**NEW MEXICO
ENVIRONMENT DEPARTMENT**

**RE: REQUIREMENT FOR SUBMITTAL OF
WASTEWATER TREATMENT PLANT DESIGN DRAWINGS
WESTERN REFINING SOUTHWEST INC., GALLUP REFINERY
EPA ID # NMD000333211
HWB-WRG-17-MISC**

**RE: RESPONSE TO NOTICE OF VIOLATION
WESTERN REFINING SOUTHWEST INC., GALLUP REFINERY
EPA ID # NMD000333211**

**RE: NOTICE OF VIOLATION
WESTERN REFINING SOUTHWEST INC., GALLUP REFINERY
EPA ID # NMD000333211**

FIGURES

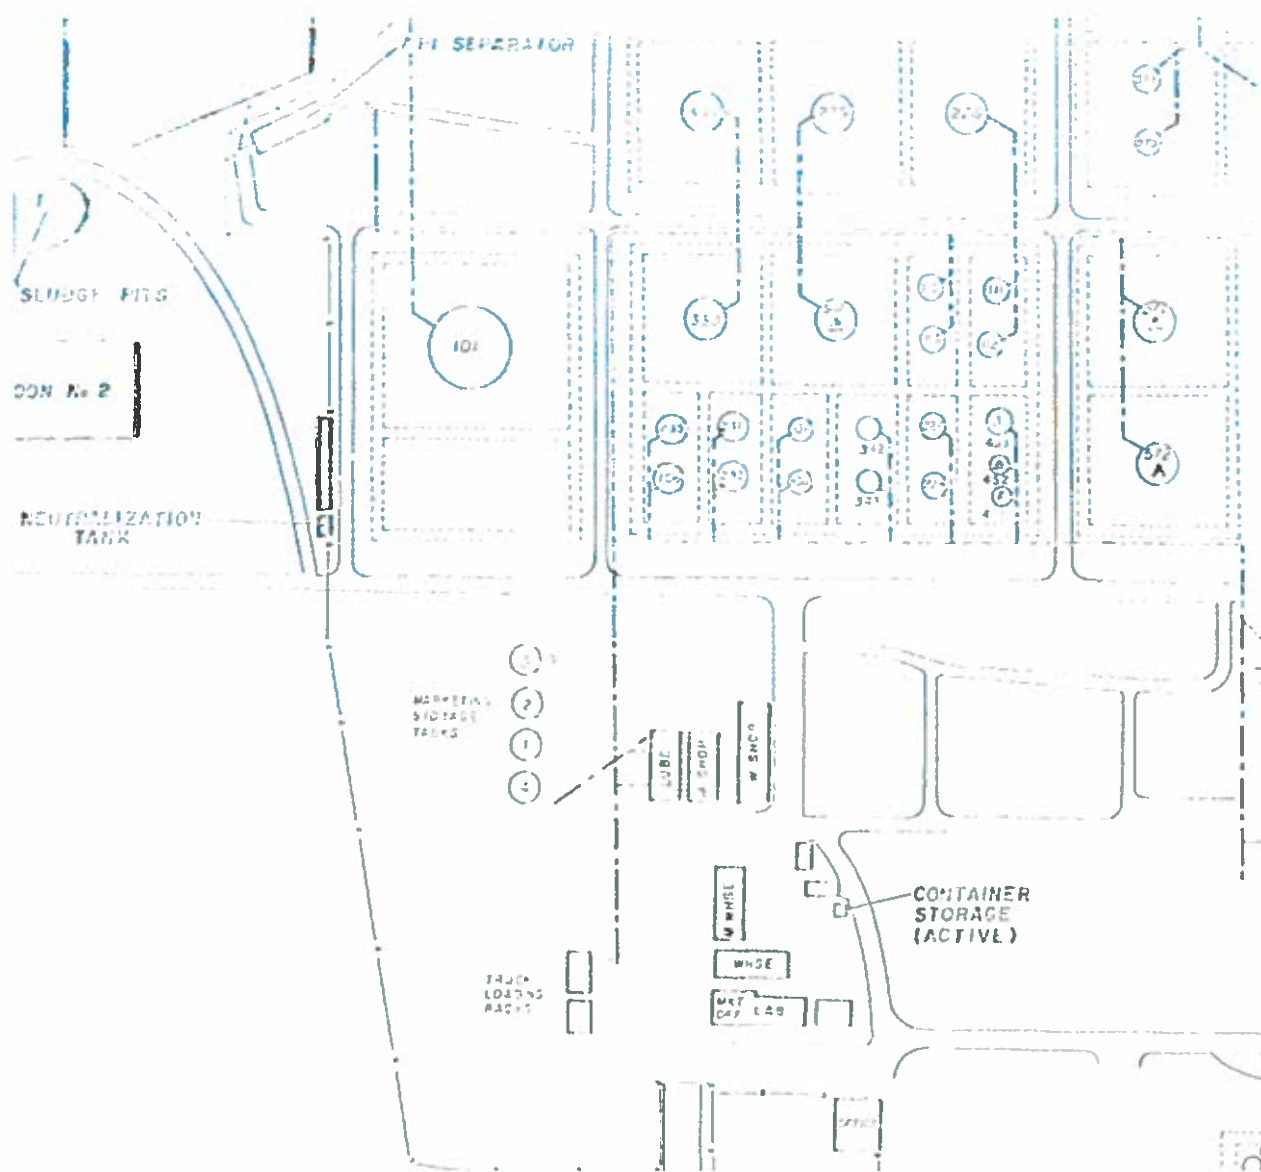
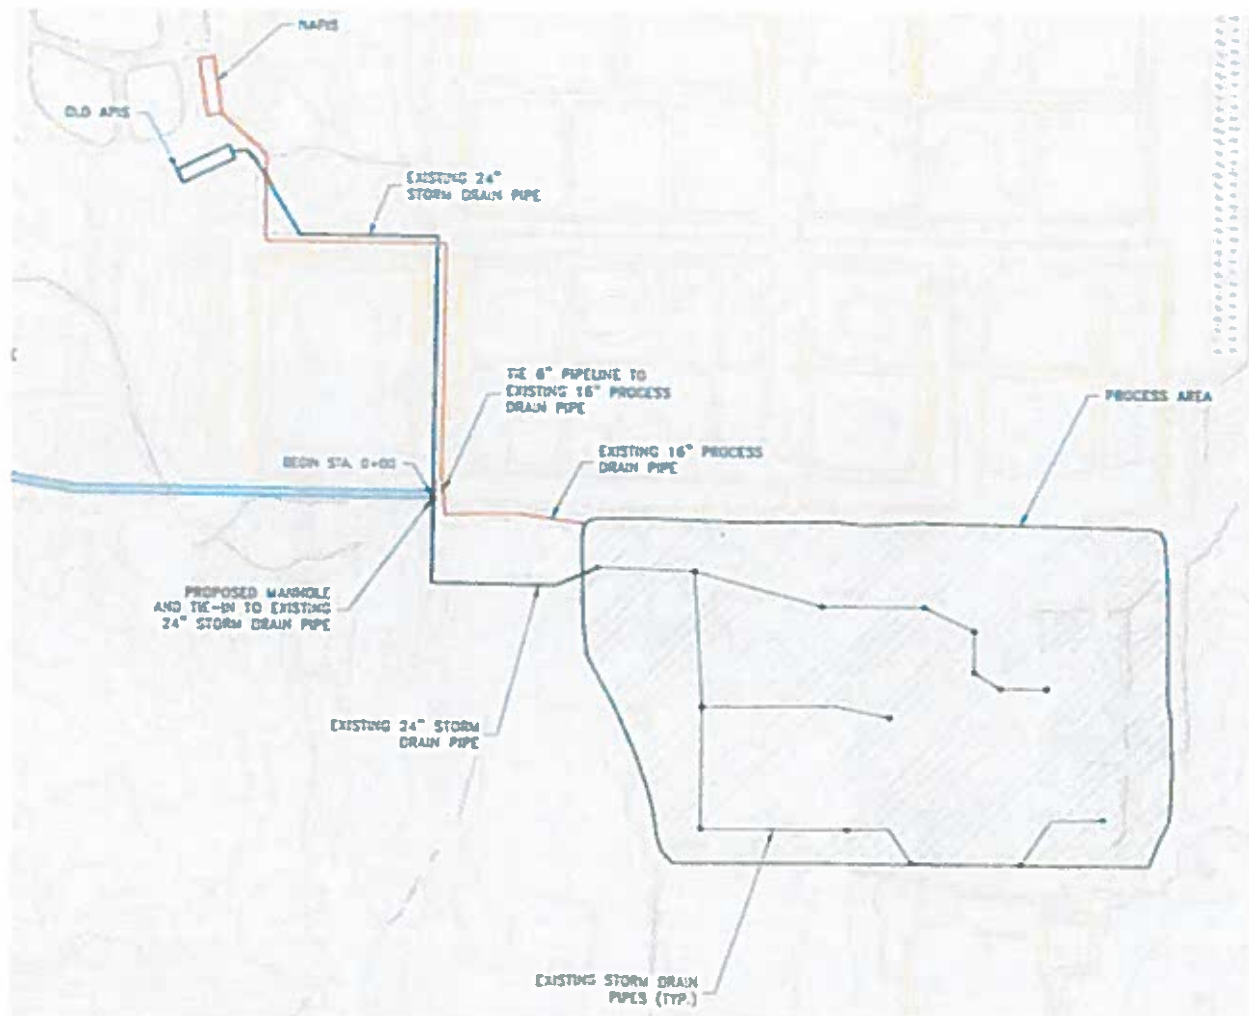
Western's descriptions and statements. NMED requires further explanation in order to withdraw the NOV. Western must provide figures that support the assertions presented in the Response (i.e., provide figures that depict SWMU 12 and depict wastewater flow directions and piping connections). Additionally, the following comments are based on figures in NMED's administrative record (Figure 1 and Figure 2, attached). Western's responses to these comments may also provide more explanation regarding the potential violations.

- In Section A (No RCRA Waste Listing is Applicable), Western states, "[t]he particular pipeline at issue in the NOV, referred to herein as the 'truck rack line' (and sometimes described geographically by its proximity to above-ground units such as Crude Tank 102 or the bundle cleaning pad) carries an intermittent water flow originating from the truck rack, and is intersected by the instrument and electrical ('I&E') maintenance shop (described more fully in Section 11.C. below) and lab sink drains. The truck rack line, a portion of which was excavated and replaced, conveyed storm water and truck loading area wash water containing small quantities of gasoline and diesel drained from trucks and hoses into the sewer system. The I&E line contributed hand wash water and instrument testing water, and the lab sinks contributed bottle washings and unused or spent water samples and hydrocarbon samples. No process wastewater was discharged into the truck rack line from these sources, and no process wastewater would enter the refinery's sewer system until a point that was downstream of the replaced line. The sole sources of the contamination in the excavated media were associated with wastewater from the truck rack, the lab sinks, and the I&E maintenance shop." Based on a figure in a document titled "Stormwater Extension Project" dated October 2007 (Figure 2) and a figure from a RCRA Facility Investigation (RFI) conducted in the 1990s depicting the contact wastewater system (Figure 1), it appears that there is: 1) a stormwater drain pipe from the Process Area that connects to the Truck Rack Line south of the Heat Exchanger Bundle Cleaning Pad; and 2) there is a wastewater line from the Marketing Tanks, Transmix Loading Rack (which is not depicted on the figure, but is depicted on a Plant Layout map in the administrative record), and the Truck Loading Racks that connects to the Truck Rack Line. Therefore, it appears that process wastewater discharges into the Truck Rack Line, as well as wastewater containing slop oil.

- Western states that "[s]lop oil and solids are primarily produced at T-35, T-27, T-28, and the NAPIS, which are at least 1,056 feet downstream to the W/NW, and at least 200 feet lower elevation than the excavated truck rack line. The excavated truck rack line, thus, could not (and did not) contain slop oil or slop oil emulsion solids. Any materials associated with the subject truck rack line could not be K049." Based on the available figures, wastewater from the Transmix Loading Rack and Marketing Tanks appears to be conveyed to the Truck Rack Line. Transmix is slop oil, and therefore it appears the Truck Rack Line contained wastewater that carried slop oil and the excavated section of pipeline and associated soils contained K049 listed wastes.

- Western states that “[t]he F037 listing is specifically limited, and applicable only, to refinery primary oil/water/solids separation sludge generated from gravitational separation during storage or treatment of process wastewaters and oily cooling wastewaters. The excavated sewer line never contained process wastewaters or oily cooling wastewaters; therefore, no sludge from gravitational separation of such materials could be present in the line. Any materials associated with the subject truck rack line could not be F037. [FOOTNOTE: Western also notes that sludge meeting the regulatory F037 hazardous waste listing would not have been at issue even if the excavated line had received process wastewaters or oily cooling wastewaters. However, that legal point is not reached in this matter since no process wastewaters or oily cooling wastewaters were present in the line.]” A more complete definition of F037 listed waste found in 40 CFR Subpart D includes “petroleum refinery primary oil/water/solids separation sludge – Any sludge generated from the gravitational separation of oil/water/solids during storage or treatment of process wastewaters from petroleum refineries. Such sludges include, but are not limited to, those generated in oil/water/solids separators; tanks and impoundments; ditches and other conveyances; sumps; and stormwater units receiving dry weather flow.” The contact wastewater and process sewer lines (SWMU 12) are connected and meet the definition of a stormwater unit receiving dry weather flow. Based on Figure 2, “Stormwater Extension Project,” it appears that a storm drain pipe from the Process Area connects to the Truck Rack Line. The waste conveyed through the excavated sewer line contained sludges with F037 listed waste. Therefore, by definition, the excavated soils carry that listing.

Western’s initial Response was insufficient and therefore Western must provide additional information in order to demonstrate that listed waste was not conveyed through the Truck Rack Line. The additional information required above may help to clarify these issues. Upon receipt of the additional information, NMED will consider whether a violation occurred during the excavation of the sewer line. NMED is also willing to meet with representatives from Western to discuss any figures or other documentation that demonstrates that the violations outlined in NMED’s NOV did not occur.
